Burlington Development Review Board

Development Review Board

Tuesday, January 7, 2025, 5:00 PM

**ZP-24-526; 72 Temple Street (RL, Ward 7) Green Mountain Habitat for Humanity
Amend ZP-22-625 for additional after-the-fact tree removal and new plantings.
(Project Manager, Scott Gustin)**

-  = Area to be cleared
-  = Area to remain wooded with
 - White Pine
 - Maple
 - Poplar

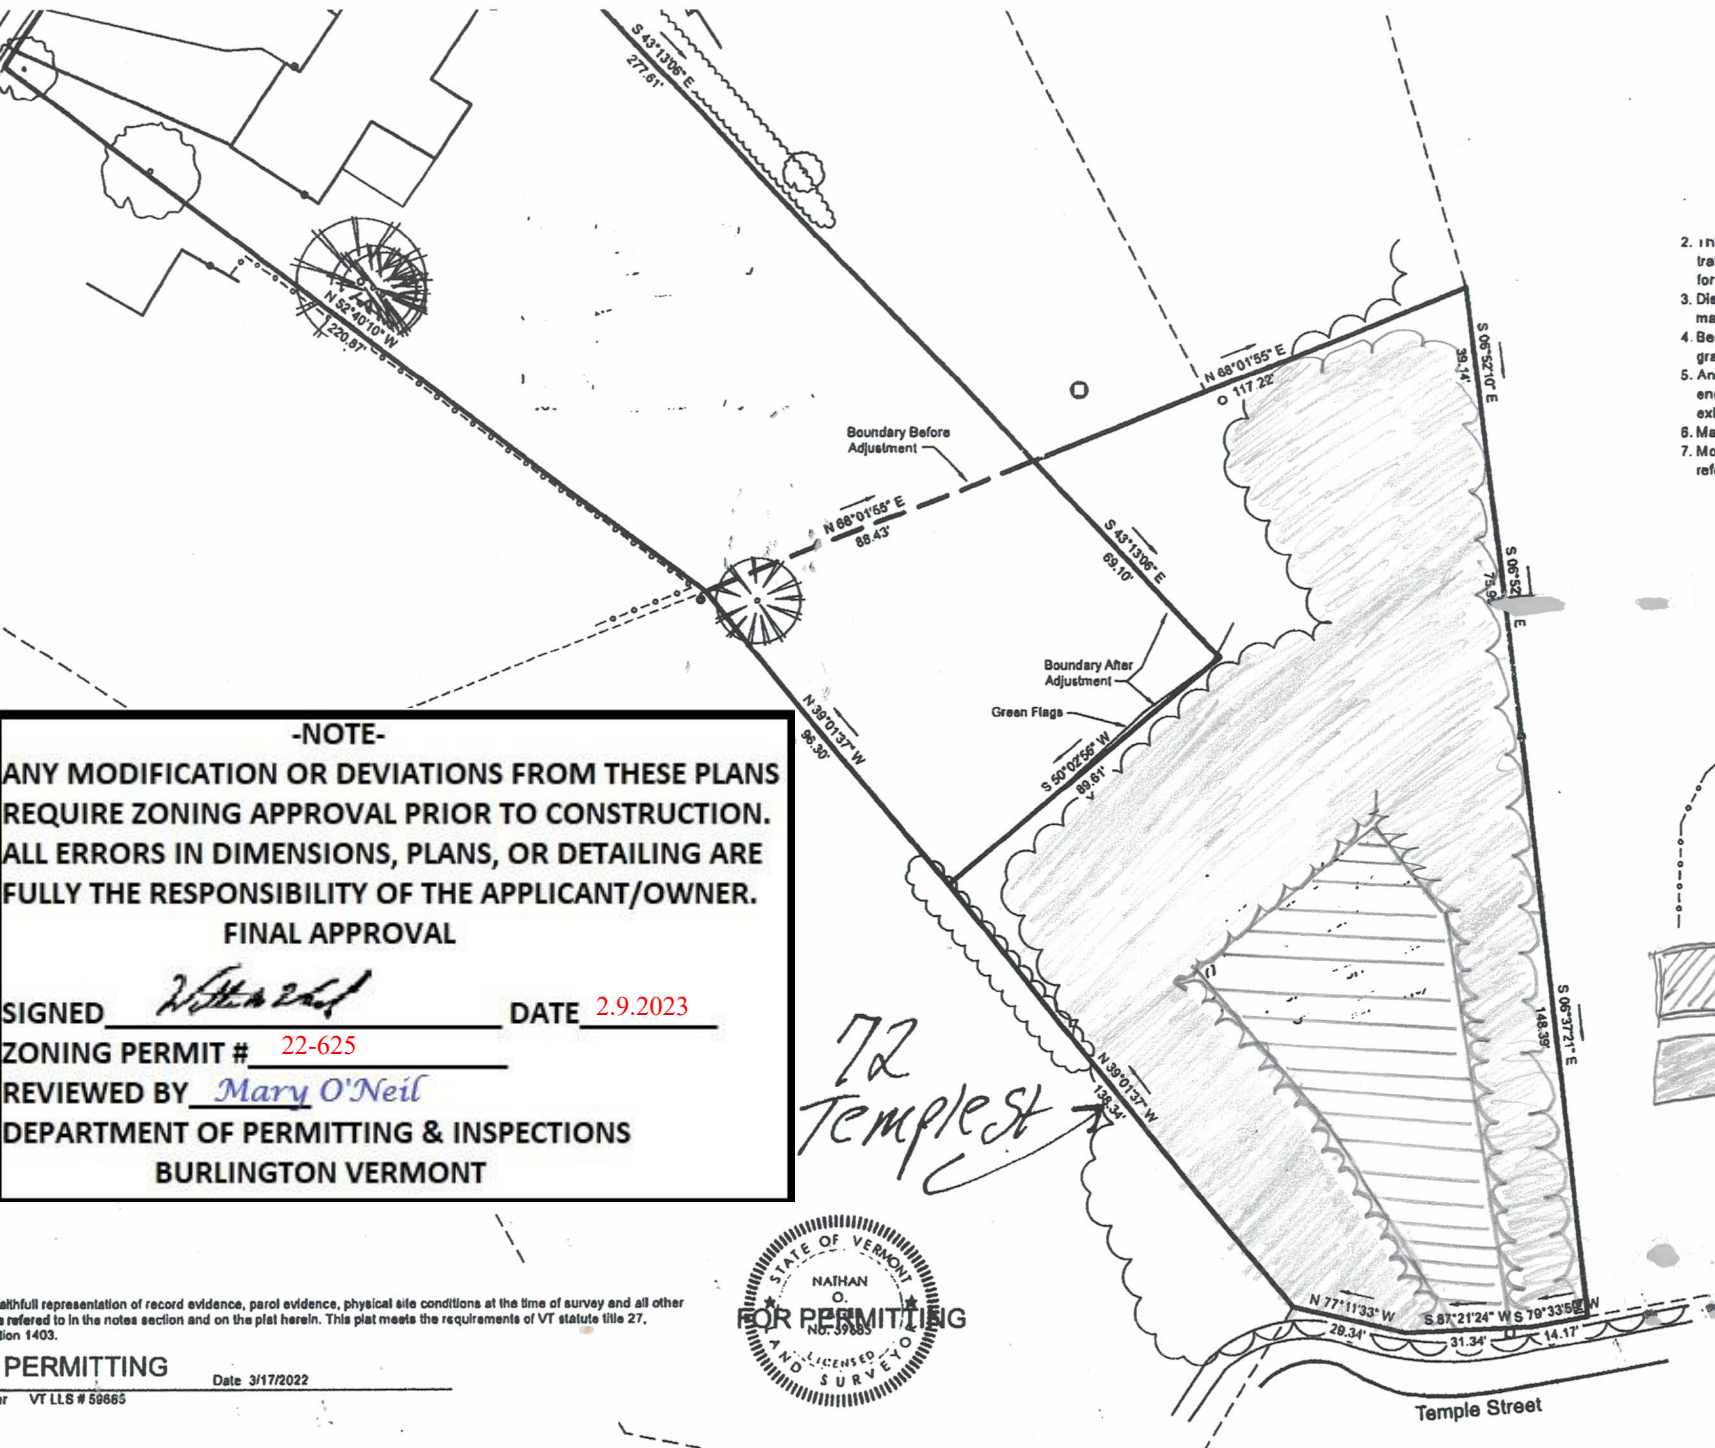
I don't see any specific plan in the application materials submitted by Green Mt. Habitat for Humanity (GMHFH/the applicant) for the DRB's review re: property line erosion mitigation. I looked over the landscaping illustration/plan and materials carefully and my initial feeling is that it does next to nothing to address the damage caused by the permit violation (GMHFH's complete destruction of permitted "tree buffer" along the eastern property line that abuts the 3 Rockland St./Rockland Condominiums (RC) property). "SEED NATIVE PERENNIAL WOOD/SHRUBS + LIVE DOGWOOD STAKES" is a grossly insufficient plan to remedy the damage and hazard created by having unlawfully removed the 8+-foot wide swath of mature hardwoods that provided both privacy and erosion control along the shared property line. It does next to nothing to address the severe loss of privacy and the dramatically exacerbated erosion hazard, and its language is extremely vague. What does it actually mean GMHFH will do? From the wording, it seems to me that, if this "plan" were approved, the applicant could plant one seed and two dogwood stakes and be in compliance. And why aren't any evergreens planned for this exposed area? Evergreens would, at the very least, eventually make up for some of the lost privacy on our property and in our home, as well as provide some measure of privacy for the occupants of the new home on Temple St.

The photos included in the application ([ZP-24-526](#)) "to amend ZP-22-625 for additional construction-related tree removal and new plantings" are from **August 20**, before the driveway was prepared, before the wall and retaining hill were built, and well before the driveway and walkway were fully paved. That seems misleading to me. The area to be "amended" not only looks completely different now, but is structurally altered pretty drastically from when these photos and application materials were submitted to the city for review. My media packet submitted for the DRB's review contains photos of the area as it looks right now. The green visible on the hill in the photos is purportedly rye, which was planted after many truckloads of rocks, boulders, and dirt were piled on the eastern (RC) side of the concrete retaining wall. Much of it slide down the hill, over the line and onto our property.

1. All plantings included in this permit shall be installed within one year of the date of permit approval.
2. Standard Conditions 1-15 (with zoning permit timeline limited to 1 year).

WALL PLAN AND
ELEVATION

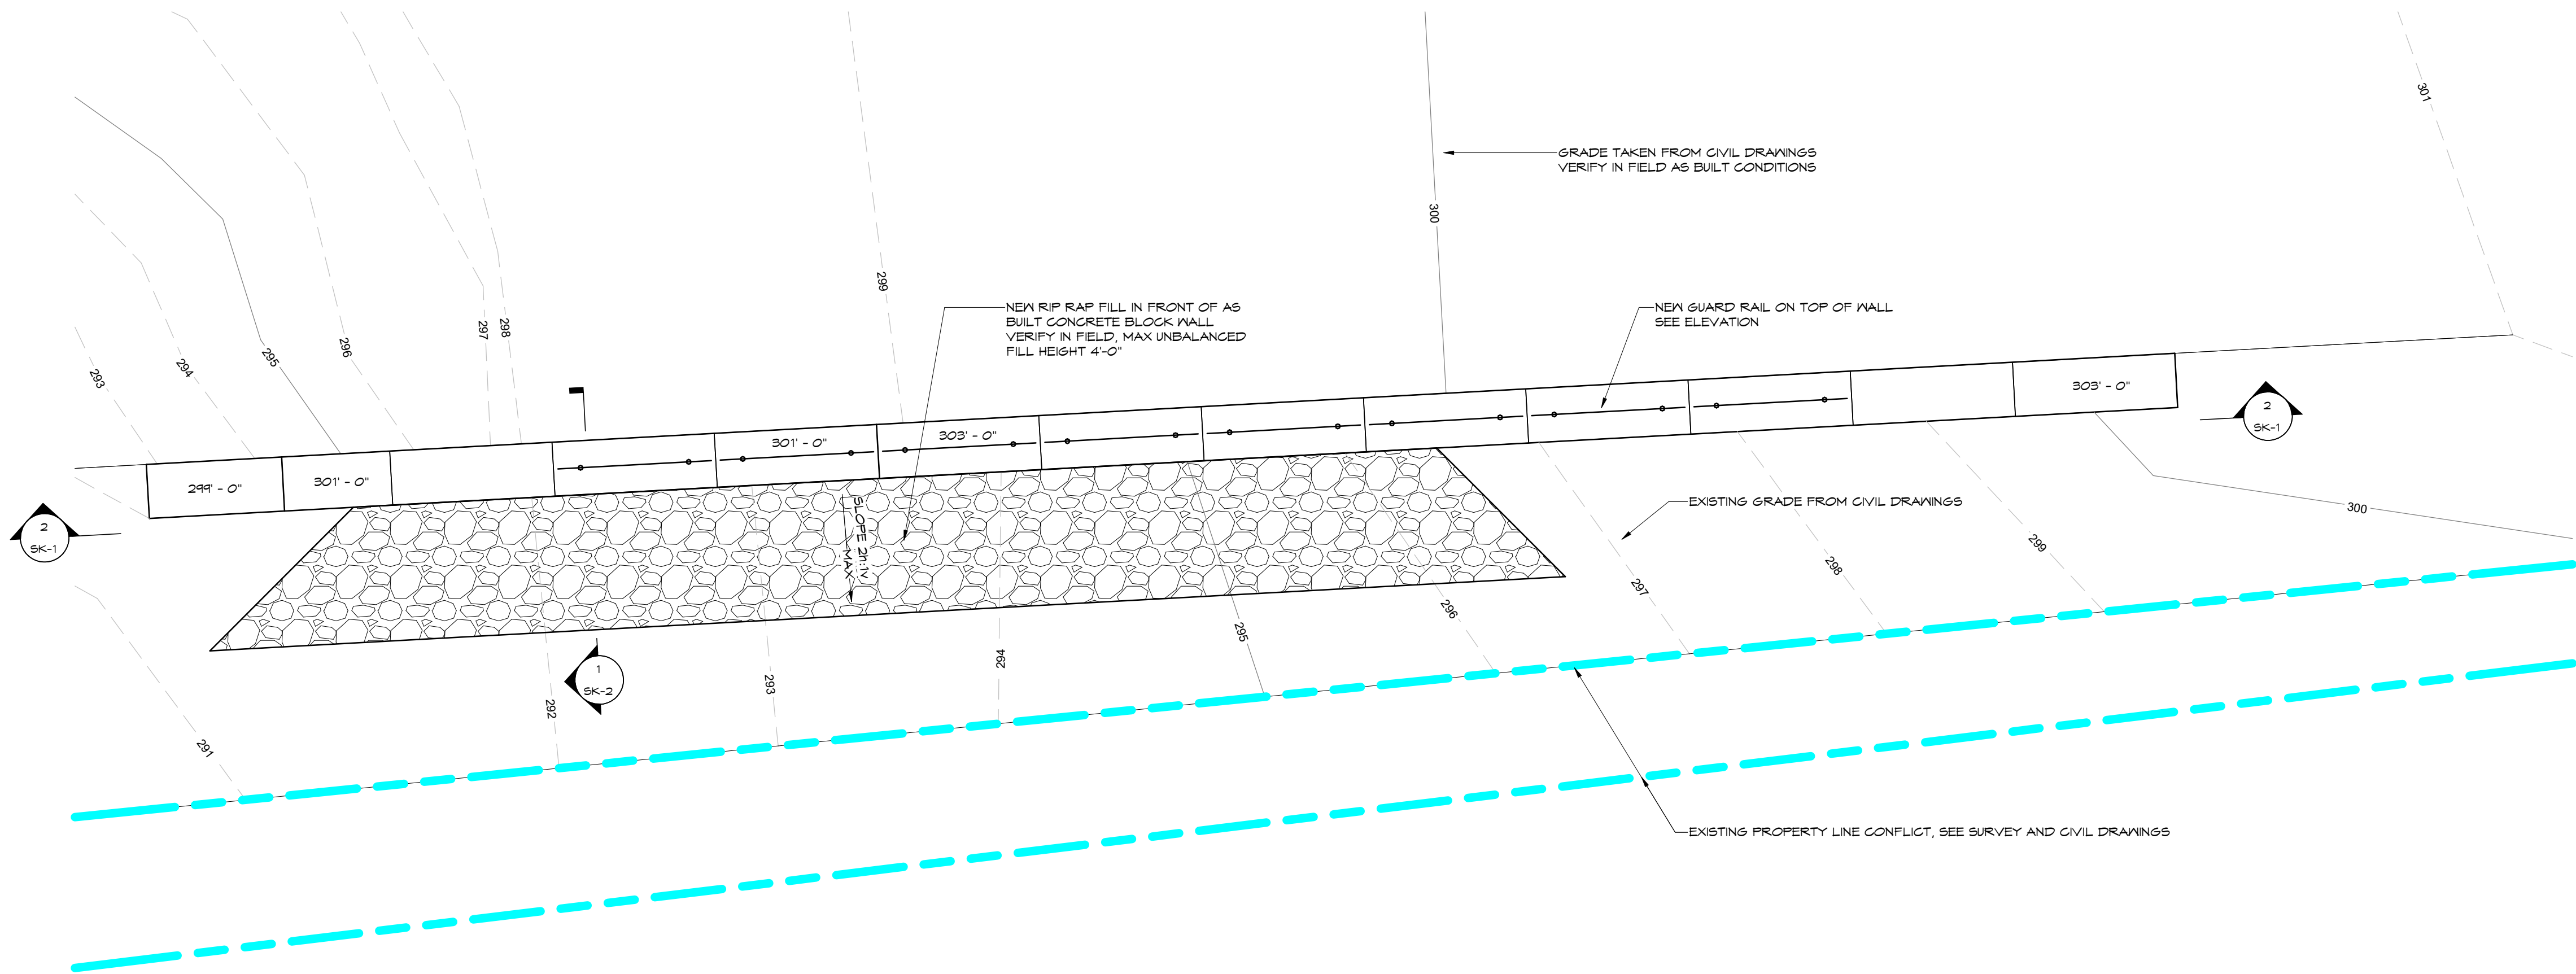
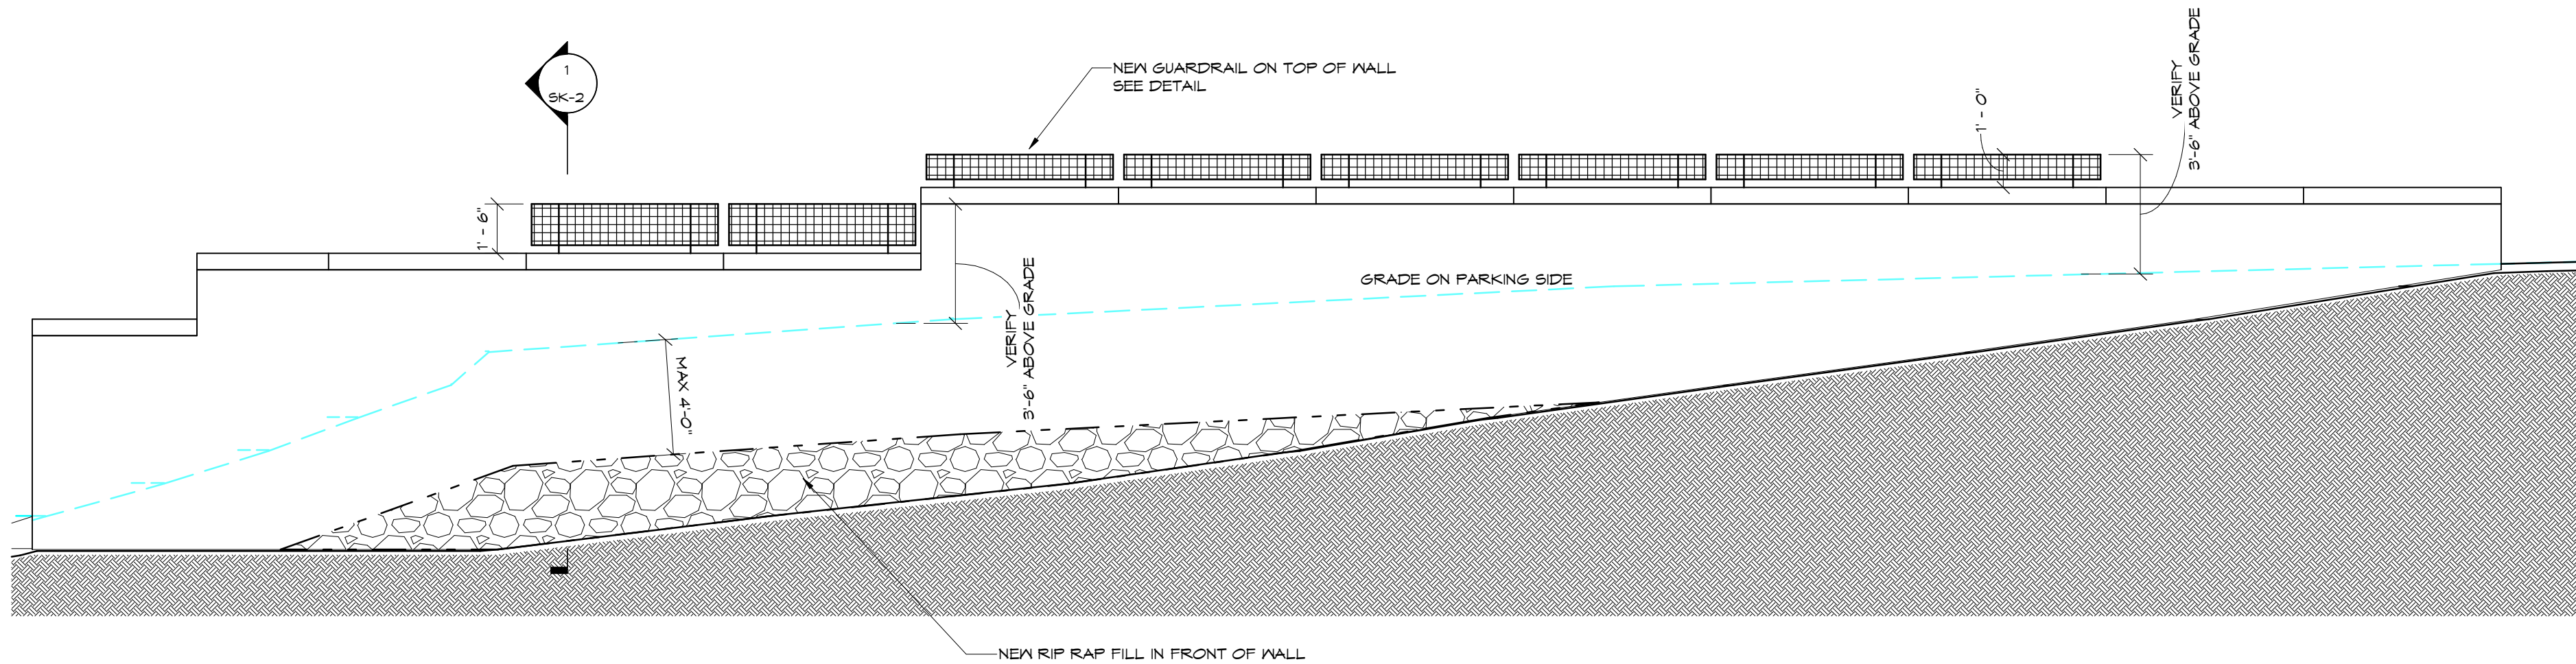
Along similar lines, the rip rap at the western end of the parking lot is substantial in area. Climbing vines planted here too is warranted. A revised landscaping plan depicting additional landscaping as noted is required. **(Affirmative finding as conditioned)**

1. **Prior to release of the zoning permit**, revised plans shall be submitted, subject to staff review and approval. The revised plans shall depict additional plantings, such as climbing vines, along the base of the retaining wall to better screen it from the neighboring property to the south. The revised plans shall also depict the rip rap and associated new plantings, such as climbing vines, at the western end of the parking lot.
2. Standard Conditions 1-15 (with zoning permit timeline limited to 1 year).
